SERVICE LETTER No. L 140

MODEL AFFECTED: Z 242 L aircraft, S/N: 0852, 0853, 0854, 0855

SUBJECT: Modification of fuel tank venting.

Fig. No. 1: Drawing of fuel tank venting assembly

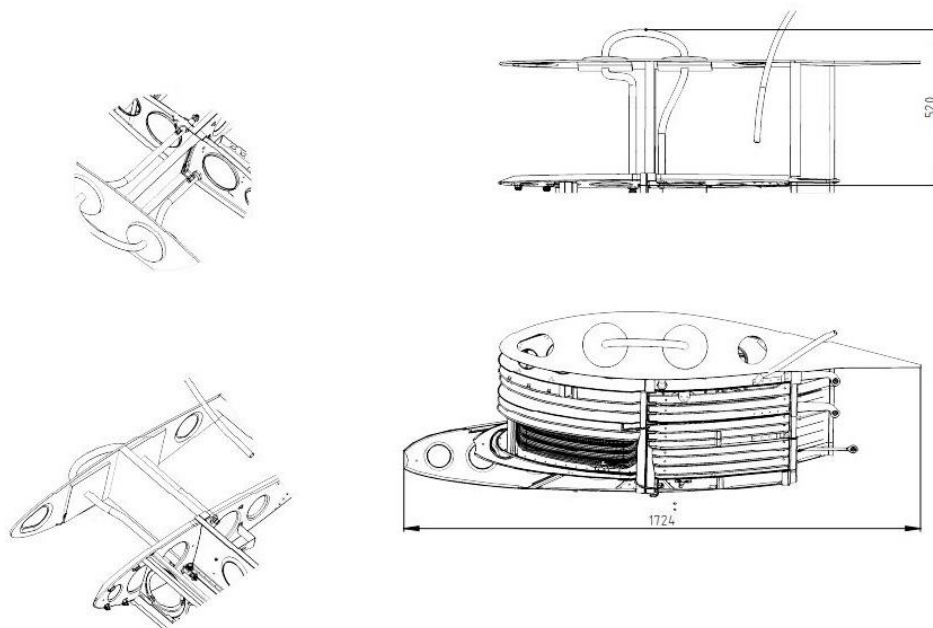
Aircraft manufacturer ZLIN AIRCRAFT a.s. made following modification of fuel tank venting:

Parts Fuel intake throat (*Drwg. No. L242.7232*) and Vent throat (*Drwg. No. L242.7233*) were connected using Hose (*Drwg. No. 990-528-00.02*).

Hose is routed through two holes by Hose guides (*Drwg. No. 990-528-00.01*) in middle of winglet's rib (*Drwg. No. Z242.2160-00.04*).

Hose is connected to fuel throats using clamp 5 ČSN 02 2752.04 and Strip 5 ČSN 02 2757.

PROCEDURES: Disassemble winglet (*Drwg. No. Z242.2160*).
Grease both ends of Hose (*Drwg. No. 990-528-00.02*) by vaseline.
Fix one end of Hose to Fuel intake throat (*Drwg. No. L242.7232*) by clamp 5 ČSN 02 2752.04 and Strip 5 ČSN 02 2757).
Stick Hose through one Hose guide (*Drwg. No. 990-528-00.01*) and insert Hose guide into winglet's rib (*Drwg. No. Z242.2160-00.04*) on corresponding side.
Pull the other end of Hose out of winglet's rib. Apply Hose guide on Hose and insert it into winglet's rib on the other side.
Fix second end of Hose to Vent throat (*Drwg. No. L242.7233*) by Clamp 5 and Strip 5.
Tighten both clamps 5 and reassemble winglet.
